Access Review

Multi-dwelling Development
8 Linksview Avenue Leonay
Report Issue 4
11/08/20

New Boarding Point at the Existing Bus Stop on Leonay Parade

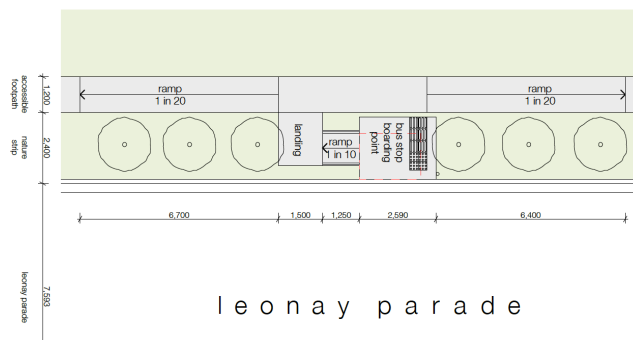
To meet the Access to Premises Standards (2010) and The Disability Standards for Accessible Public Transport (DSAPT) (2002), the proposed bus stop boarding point and accessible linking pathway is shown below (source: IDG Architects).

- Continuous accessible path of travel to the bus stop area with circulation space in accordance with AS1428.1
- A 1:10 gradient step ramp with gradient, kerbs and handrails in accordance with AS1428.1
- Accessible pathway surfaces with landings and level transitions in accordance with AS1428.1
- Walkways in accordance with AS1428.1 clause 10
- Bus Boarding Point with sufficient circulation space of 1540mm x 2070mm in accordance with the DSAPT and maximum gradient of 1:40
- Tactile ground surface indicators installed in accordance with the requirements of AS1428.4.1 leading to the boarding point

Excerpt from Survey of footpath gradient from proposed development to bus stop on Leonay Parade prepared by RHCO, dated 03/02/20

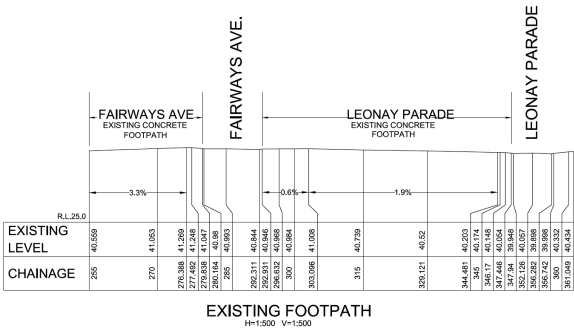
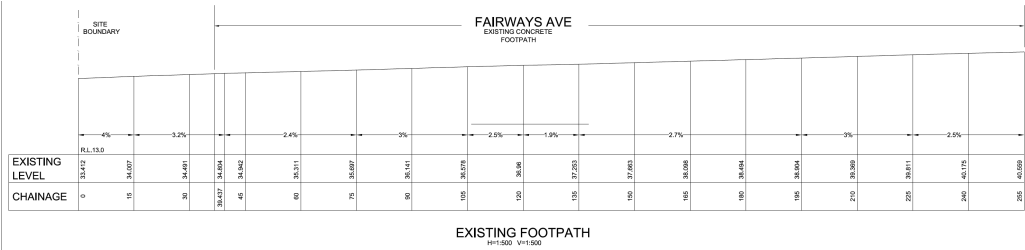
The contour and detail survey prepared by RHCO Surveyors (excerpt on following page) shows that the gradient of the existing and proposed footpath (0.6% - 4%) is within the allowable gradients set out in State Environmental Planning Policy - (Housing for Seniors or People with a Disability) 2004 part 2 clause 26 of:

Based on the survey information provided and inclusion of the proposed design of the new section of footpath, in our opinion the site complies with the requirements set out in the State Environmental Planning Policy - (Housing for Seniors or People with a Disability) 2004 part 2 clauses 26 and 38 for location and access to facilities.
